Doosan Infracore
Portable Power

Service Letter

SL: 40015
Date: 31 June 2010
Product: Compressors
Subject: Heavy Duty Hose Clamp Modification

Figure 1

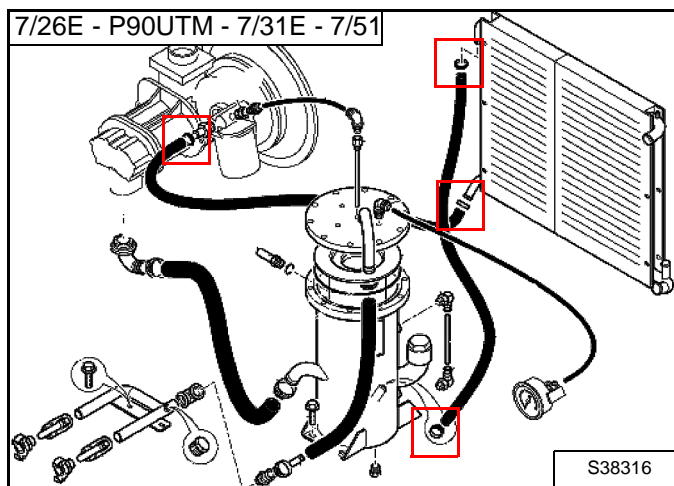
Doosan Infracore has determined that the oil hoses between the cooler and separator vessel can disconnect during compressor operation.

Therefore heavy duty clamps need to be installed to replace the standard clamps on the critical connections of the compressors listed in this letter [Figure 1] & [Figure 2].

Figure 1

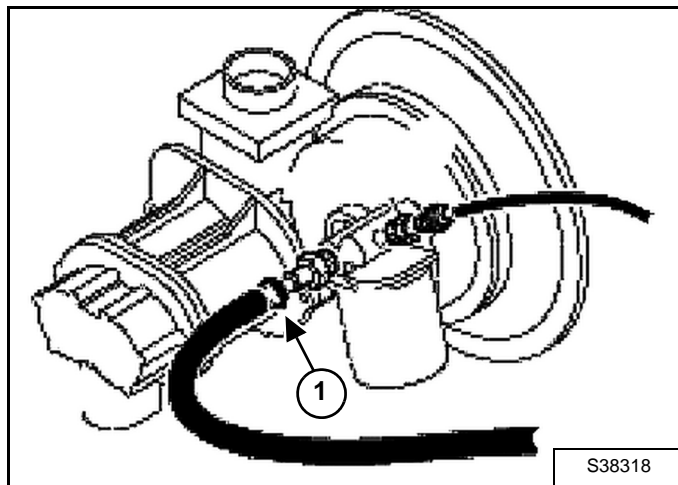
Remove the clamp (P/N 46501862) (Item 1) **[Figure 1]** from the hose.

Install a heavy duty clamp (P/N 46553673) (Item 1) **[Figure 1]** on the hose and tighten to 11 ft.-lb. (15 N•m) torque.

Figure 2

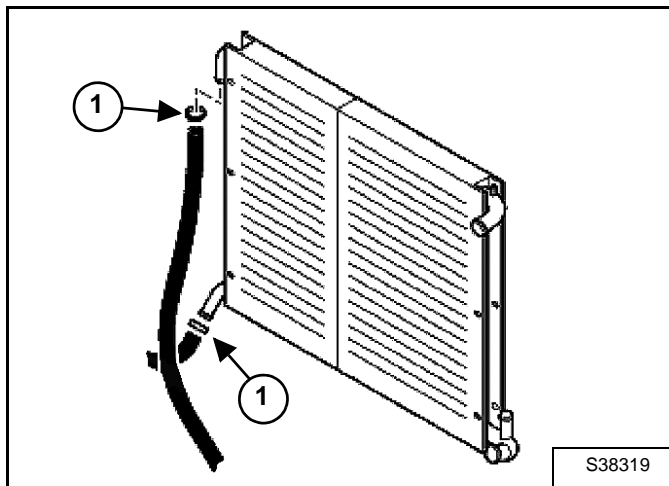
Remove the two clamps (P/N 46501862) (Item 1) **[Figure 2]** from the hoses.

Install two heavy duty clamps (P/N 46553673) (Item 1) **[Figure 2]** on the hoses and tighten to 11 ft.-lb. (15 N•m) torque.

Figure 3

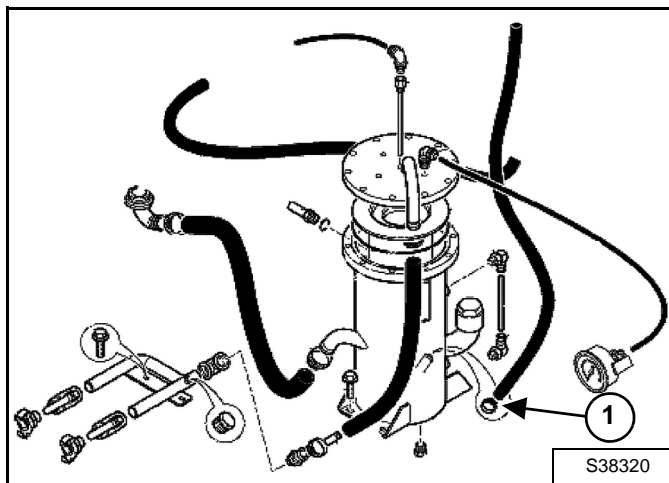
Remove the clamp (P/N 46501862) (Item 1) **[Figure 3]** from the hose.

Install a heavy duty clamp (P/N 46553673) (Item 1) **[Figure 3]** on the hose and tighten to 11 ft.-lb. (15 N•m) torque.

Figure 4

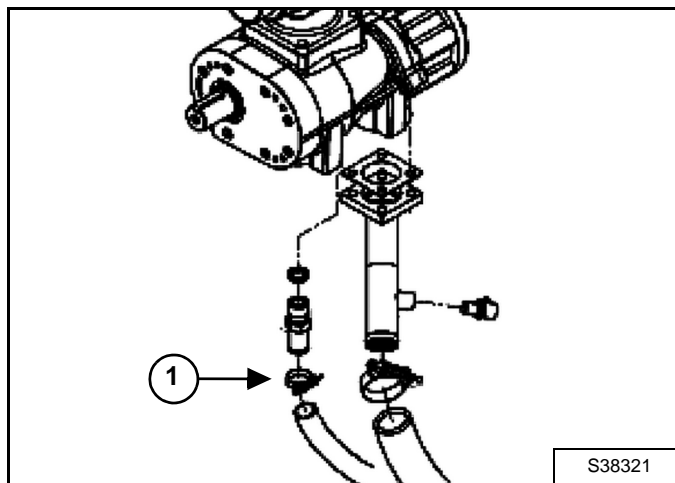
Remove the clamp (P/N 46501862) (Item 1) **[Figure 4]** from the hose.

Install a heavy duty clamp (P/N 46553673) (Item 1) **[Figure 4]** on the hose and tighten to 11 ft.-lb. (15 N•m) torque.

Figure 5

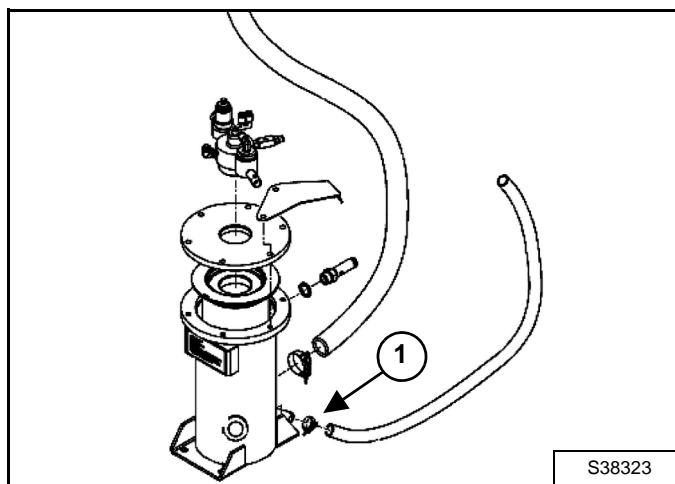
Remove the clamp (P/N 46501862) (Item 1) **[Figure 5]** from the hose.

Install a heavy duty clamp (P/N 46553673) (Item 1) **[Figure 5]** on the hose and tighten to 11 ft.-lb. (15 N•m) torque.

Figure 6

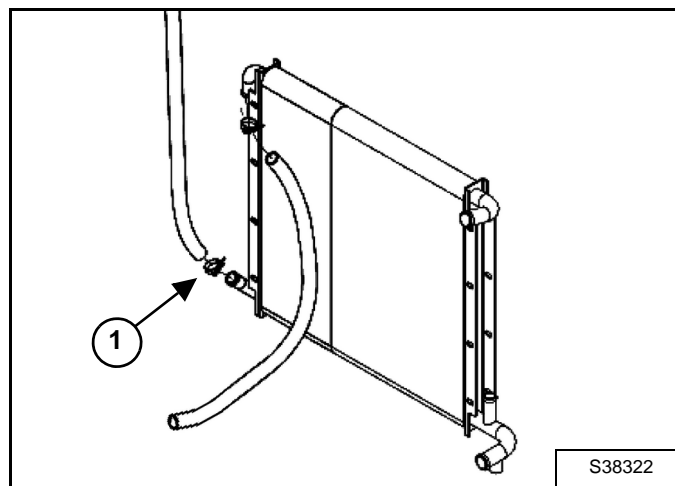
Remove the clamp (P/N 46501862) (Item 1) **[Figure 6]** from the hose.

NOTE: The clamp on the cooler inlet hose will not be replaced because there is not enough room to do so.

Install a heavy duty clamp (P/N 46553673) (Item 1) **[Figure 6]** on the hose and tighten to 11 ft.-lb. (15 N•m) torque.
